**Licence Number** L6079/1988/13

**Licensee** Newcrest Mining Limited

**Premises** Telfer Gold Mine  
Mining Tenements M45/6-11, M45/33, M45/203-211,  
M45/249, M45/631-633, M45/709, M45/710, G45/1-4,  
L45/99, L45/100 and L45/106  
TELFER WA 6762

**Date of Amendment** 4 December 2017

Figure 4 – Inert Waste Landfill Areas

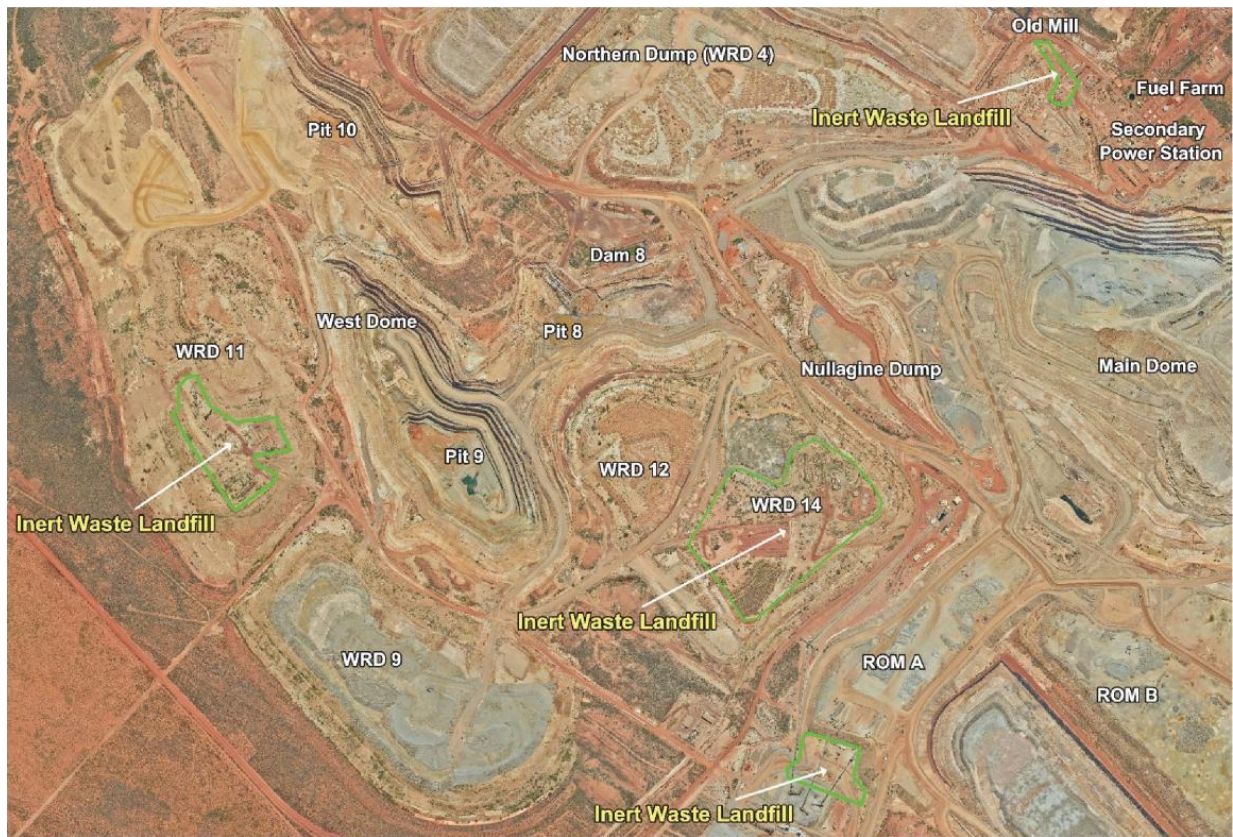
16. The Licence is amended by the replacement of Figure 4 in Schedule 1 with the following updated map.
